Herefordshire Local Plan

Hereford Area Plan

Housing and Employment Site Options Consultation

Technical Site Assessments - North East Hereford

Bur21

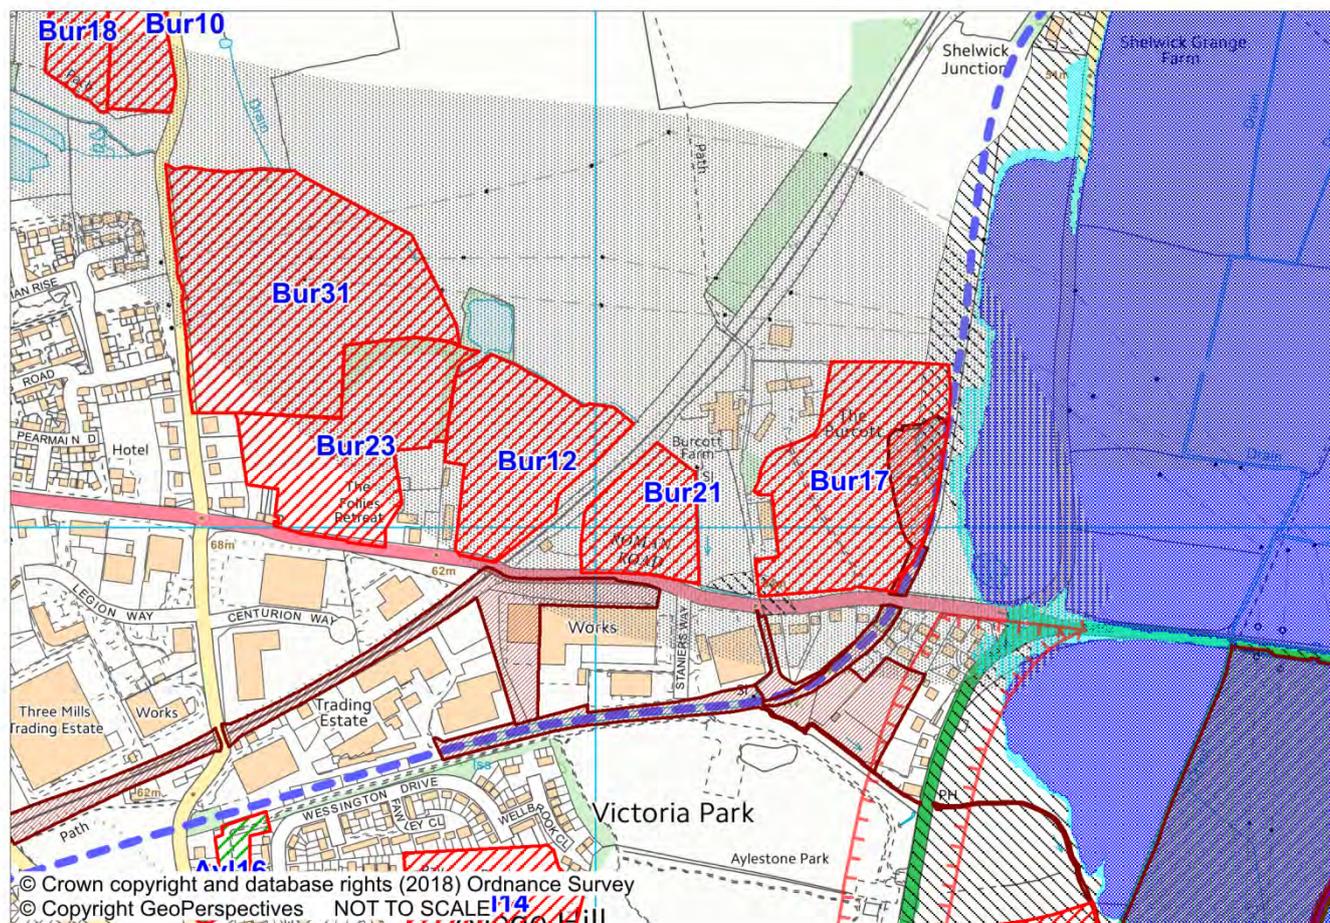
HC Highways comments
Public Transport accessibility comments
<p><i>Are standards for access to local services likely to be achievable?</i></p> <p>Bus services are available on Aylestone Hill, with footways on the southern side of A4103 from Staniers Way to Aylestone Hill for connectivity. There are however no footways to the west to the employment areas west of the railway line which does sever any pedestrian connectivity between the site and schools and other facilities to the west.</p>
Access comments
<p>A suitably designed and acceptable access onto A4103 Roman Road would be difficult to achieve due to proximity to the railway bridge and Staniers Way junction. If Bur17 was brought forward as well, spacing of junctions may be a constraint. Pedestrian crossing points would need to be provided.</p>
Local network comments
<p><i>Any capacity concerns on this section of the network?</i></p> <p>Signalised railway bridge to the west is a constraint and suffers from queuing during peak hours, and issues with Starting Gate roundabout further west. Aylestone Hill to the east and into the city centre suffers from queuing at peak hours and the impact of the new city link road appears to have exacerbated this.</p> <p>The network impact would need to be covered in a Transport Assessment/Statement comparing vehicle movements and as with all HAP sites the scope and developments to be considered will need to be confirmed.</p>

Site dependence on Hereford Transport Package
<p>An overall assessment of the acceptability with regard to highway network capacity will need to be carried out (once all sites are reviewed and shortlisted) to assess the cumulative impact and at which stage of the HTP those developments can be brought forward.</p>
Mitigation measures
<p>Delivery of HTP to provide network capacity.</p>
Highway site support
<p>The site falls within the corridor for the final section of HRR (A49 to A4103(E)) and therefore until such time as a line is finalised, or it is decided not to pursue that section, development could prejudice the delivery of that section of the road.</p> <p>If the site did not impact the relief road, unless an acceptable access can be provided, this site would not be considered an acceptable site for development. If satisfactory access can be achieved, subject to network capacity at the time the site is brought forward, with the sustainable connectivity concerns to the west it still may not be a suitable location for development.</p>

HC Landscape comments
<p>Situated in final phase of road corridor. A landscape assessment should be carried out after the road alignment has been identified to determine the landscape capacity of the site.</p>

HC Conservation comments
Built conservation
<i>Not assessed</i>
Archaeology
<i>Not assessed</i>
Biodiversity/Ecology
HRA – River Wye SAC/SSSI
All foul water should be managed through connection to main sewer network. Confirmation that this is possible and also acceptable to Welsh Water is necessary. No direct discharge of any foul water outfall from any onsite treatment system in to any watercourse or culvert will be considered acceptable. All surface water will need to be managed on site through a Sustainable Drainage system (SuDS).
Protected Species (in line with NPPF, NERC Act, Core Strategy LD1-3)
Any demolition of existing building or structure or significant site clearance of vegetation will trigger a requirement for an Ecological Survey.
Open Space requirements
<i>No assessment necessary at present.</i>
Development Management
<i>See conclusion</i>

Historic England
<i>Issues & Options Consultation 2017 comments: A4013 is a Roman Road, consider in heritage assessment.</i>

Conclusion			
Bur21 is a relatively flat grassland site. It is bound by the rail line to the NW and mapping shows evidence of historic contamination and that the site is covered by the HRR consultation corridor. Assessment of noise from the railway is essential.			
The site is identified under the British Geological Survey GeoIndex (onshore) mapping as a site with sand and gravel reserves. Although a useful resource, the Council would not seek to quarry so close to an urban environment.			
The site is situated in the final phase of the road corridor (Core Strategy Figure 4.2). No route alignment work has been carried out on this section of the road as the Hereford Transport Package work currently focuses on the route section going from the A49 south of the city to the A49 north of the city. Identification of a route for the final phase is not expected until much later in the Plan period (up to 2031). It would be premature to provide an assessment of site potential where a road route is expected to be accommodated beforehand.

Therefore, for the purposes of the Hereford Area Plan, this site is not considered to have development opportunity.			
Evidence of site availability	Yes	Information source	Call for sites 2017
Suitable for employment land	No

Bur23

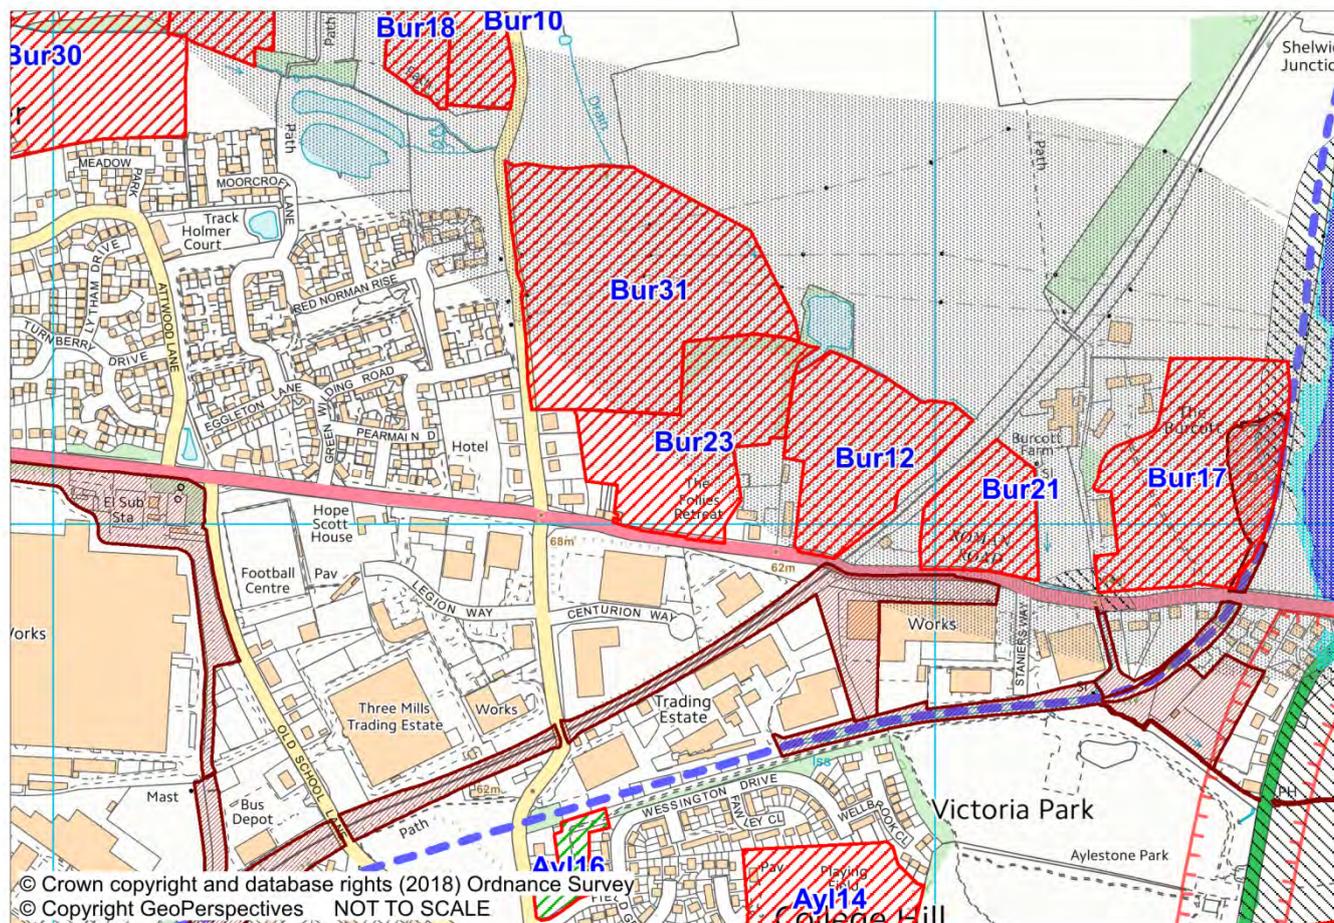
HC Highways comments
Public Transport accessibility comments
<p><i>Are standards for access to local services likely to be achievable?</i></p> <p>No. Pedestrian access to the south along College Road results in the need to cross the railway bridge on a bend without any footway provision available. Similar situation to the east on A4103 due to the signalised railway bridge. Whilst an application at Holmer Trading Estate for residential development proposed changes to College Road bridge, this has not yet been determined due to S106 issues. Bus route on Roman Road and College Road.</p>
Access comments
<p>An access would be likely to be achievable to Roman Road but depending upon turning movements a right turn lane may be required which may not be achievable in highway land. Visibility splays may require third party land. The network capacity over the railway bridge would need to be reviewed. Bur 31 may also need to access through this site, if developed, due to the inadequacy of Munstone Lane.</p> <p>The network impact would need to be covered in a Transport Assessment/Statement comparing vehicle movements and as with all HAP sites the scope and developments to be considered will need to be confirmed.</p>

Local network comments
<p><i>Any capacity concerns on this section of the network?</i></p> <p>Yes. At A4103 railway bridge, College Road and issues with Starting Gate roundabout further west. Aylestone Hill to the east and into the city centre suffers from queuing at peak hours and the impact of the new city link road appears to have exacerbated this.</p> <p>An overall assessment of the acceptability with regard to highway network capacity will need to be carried out (once all sites are reviewed and shortlisted) to assess the cumulative impact and at which stage of the HTP those developments can be brought forward.</p>
Site dependence on Hereford Transport Package
<p>A review of the cumulative network impacts of the sites would be necessary to assess whether delivery of this development this was dependant upon HTP.</p>
Mitigation measures
<p>Delivery of HTP may increase network capacity.</p>
Highway site support

HC Landscape comments
<p>The land is laid to pasture and is relatively flat and bounded by hedgerow and relates to the Roman Road from which it can be accessed. There is an extensive mature tree belt which follows the watercourse along part of the northern boundary, however a ridge of higher ground beyond this will afford clear views of the site.</p> <p>Mitigation – Retention and strengthening of boundaries, further planting along watercourse.</p>

HC Conservation comments
Built conservation
<i>Not assessed</i>
Archaeology
<i>Not assessed</i>
Biodiversity/Ecology
<i>Not assessed</i>
Open Space requirements
<i>No assessment necessary at present.</i>
Development Management
The site is not the subject of any landscape or ecology designation and it does not appear to affect the setting of any heritage assets. Mapping confirms that the greater part of the site is within the HRR corridor and also advises as to the potential for contamination. Anecdotal evidence tends to the view that there may have been landfill historically. If this is the case, it would be necessary to investigate this in more detail.

Historic England - Issues & Options Consultation 2017 comments: A4103 is a Roman Road, consider in heritage assessment.
--

Conclusion			
<p>Fairly flat grassland site with some mild undulations. There is housing to the east and west and employment to the south. The site lies to the north of and has a frontage with A4103. There is a Semi natural habitat on part of site. The site is identified under the British Geological Survey GeoIndex (onshore) mapping as a site with sand and gravel reserves. Although a useful resource the Council would not seek to quarry so close to an urban environment.</p> <p>The site is situated in the final phase of the road corridor (Core Strategy Figure 4.2). No route alignment work has been carried out on this section of the road as the Hereford Transport Package work currently focuses on the route section going from the A49 south of the city to the A49 north of the city. Identification of a route for the final phase is not expected until much later in the Plan period (up to 2031). It would be premature to provide an assessment of site potential where a road route is expected to be accommodated beforehand. Therefore, for the purposes of the Hereford Area Plan, this site is not considered to have development opportunity as a housing site.</p>

Bur29

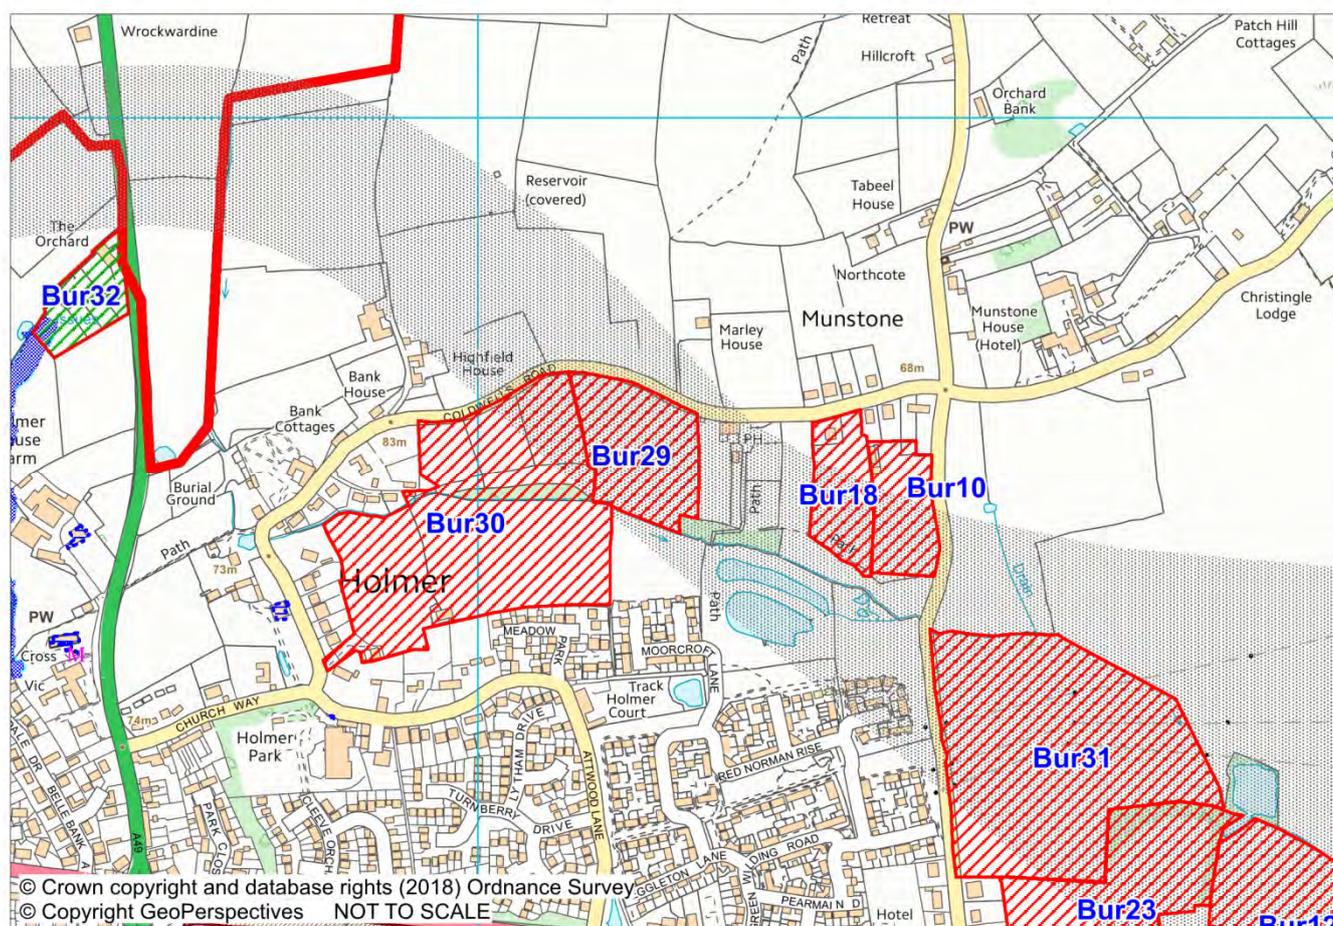
HC Highways comments
Public Transport accessibility comments
<i>Are standards for access to local services likely to be achievable?</i> No. The site fronts Coldwells Road, a narrow lane without footways. The only option to access the footways is via a footpath heading southwards to Crest site, but this would not be considered an acceptable all weather 24 hr route.
Access comments
Coldwells Road is a narrow single lane road and not suitable to serve this development. Improvements to Coldwells Road and Mustone Road to a suitable standard would involve multiple third party ownerships and is not considered viable. Possible vehicular access from the south via the Crest site will be unlikely due to the tortuous route, road widths provided within that development and the total number of houses already served by the one point of access. Therefore there does not appear to be any viable access. Should an access be found, the network impact would need to be covered in a Transport Assessment/Statement comparing vehicle movements and as with all HAP sites the scope and developments to be considered will need to be confirmed.

Local network comments
<i>Any capacity concerns on this section of the network?</i> Capacity/standard of Coldwells Road and Munstone Road not considered acceptable to serve development. Capacity issues further afield on Roman Road to the west and east.
Site dependence on Hereford Transport Package
The site falls within the corridor for the final section of HRR (A49 to A4103(E)) and therefore until such time as a line is finalised, or it is decided not to pursue that section, development could prejudice the delivery of that section of the road. An overall assessment of the acceptability with regard to highway network capacity will need to be carried out (once all sites are reviewed and shortlisted) to assess the cumulative impact and at which stage of the HTP those developments can be brought forward.
Mitigation measures
None considered achievable to secure suitable access.
Highway site support
This site is not considered to have acceptable vehicle or sustainable mode access, and therefore is not considered deliverable.

HC Landscape comments
Site description: Sloping site to the immediate north of Ayles Brook and south of Coldwells Rd (opposite Highfield House). Sloping towards brook. Very important to the character of Coldwells Lane.
Landscape and visual sensitivity: High
Capacity for housing development: Low. The development of this site would be very harmful, with or without Bur30 coming forward.

Potential mitigation measures: No mitigation is possible for the change in character which is considered to be extremely harmful.

Overall comment on suitability: Alignment of relief road will clearly influence long term future of this site.

The site is not subject to any ecological or landscape designation. There are designated heritage assets in the vicinity, but none bordering the site. Separate comments should be sought from the Conservation Section in this regard.

If considered in isolation, Bur 29 could be construed as divorced from development and thus likely incongruous in landscape character and visual terms. Moreover, given the characteristics of Coldwells Road i.e. its narrowness and the lack of forward visibility, the formation of a vehicular access to serve Bur 29 would appear problematic.

This site is a paddock in predominantly open fields. Site slopes gently down in a southerly direction it is adjacent to Bur30 which is another site that has been assessed in the Options consultation.

The site is situated completely in the final phase of the road corridor (Core Strategy Figure 4.2). No route alignment work has been carried out on this section of the road as the Hereford Transport Package work currently focuses on the route section going from the A49 south of the city to the A49 north of the city. Identification of a route for the final phase is not expected until much later in the Plan period (up to 2031). It would be premature to provide an assessment of site potential where a road route is expected to be accommodated beforehand. Therefore, for the purposes of the Hereford Area Plan, this site is not considered to have development opportunity as a housing site. Alignment of ring road will clearly influence long term future of this site.

Bur30

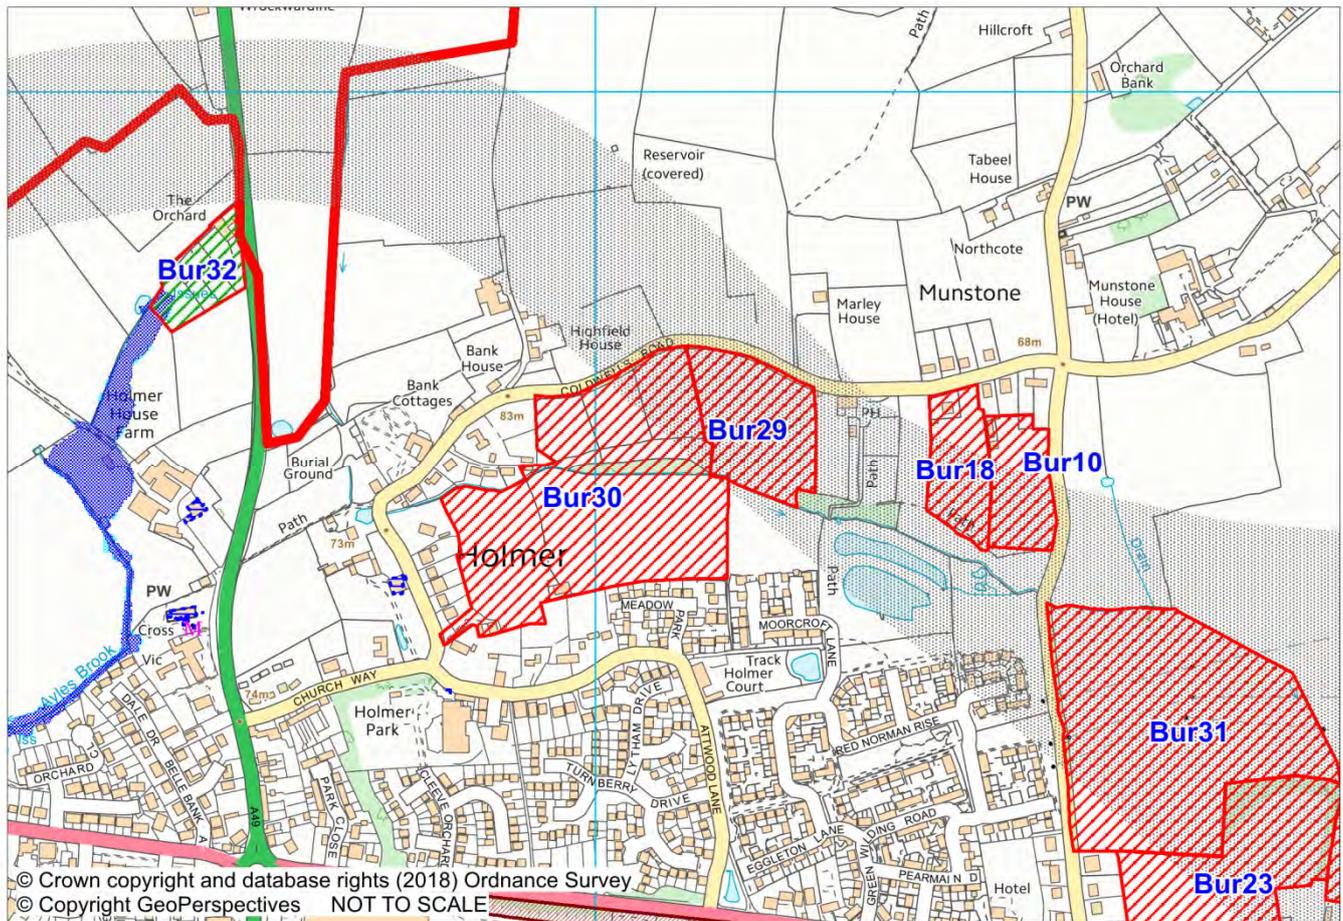
HC Landscape comments
Site description: Undulating site to the immediate south of Ayles Brook and accessed via Coldwells Rd. Undulations in centre of west side suggest historical quarrying or other archaeological activity that needs to be assessed.
Landscape and visual sensitivity: High
Capacity for housing development: This is clearly open countryside. Consider no capacity due to open countryside character and harmful visual impacts.
Potential mitigation measures: None possible. Final judgements do depend on road alignment.
Overall comment on suitability: Development would be very harmful but road alignment would change baseline.

The provision of a suitable means of access appears to be a key issue here. The junction of the A49 and Church Way has undergone some limited 'improvement' in conjunction with existing planning permissions, but the carriageway remains conspicuously narrow and prone to on-road parking; making it, in effect, a single lane carriageway. The alternative approach via Attwood Lane is similar, whilst the junction with Coldwells Road offers poor visibility and would presumably necessitate a significant overhaul. Whether sufficient land is available within the highway extent would need to be determined. Pedestrian and cycle linkages also appear difficult to resolve.

Currently, the landscape sensitivity on this site is high and it is recommended that no development takes place here. The highways assessment points to major issues with access for this site as well as the capacity of the network to accommodate further growth because of the existing narrow lanes. Not until the alignment of the road is identified will the final potential of this site be possible to establish.

Tup28

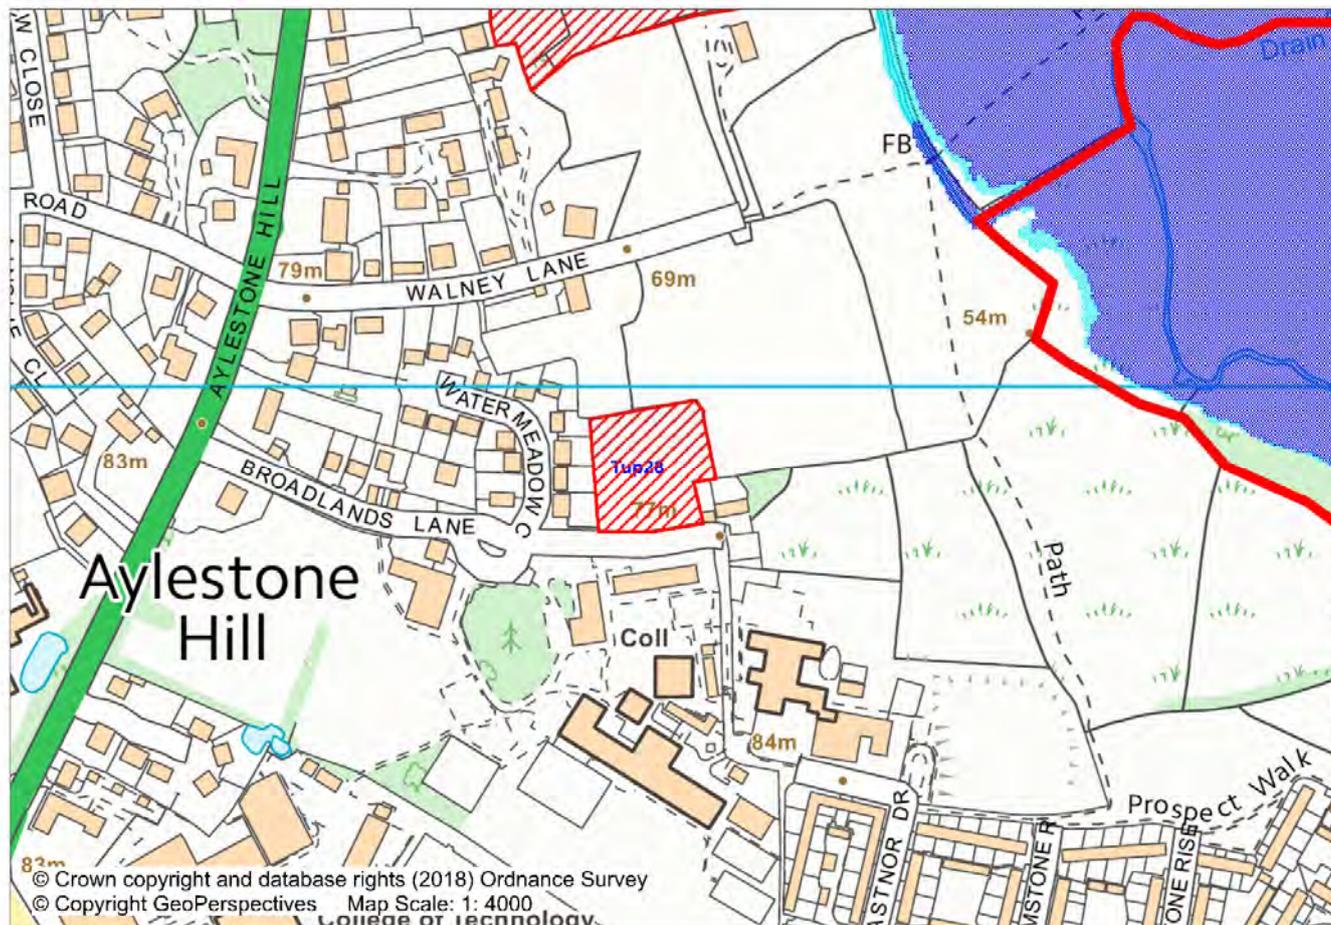
Overall comment on suitability: Might be possible to get low number of high quality units. LVIA required.
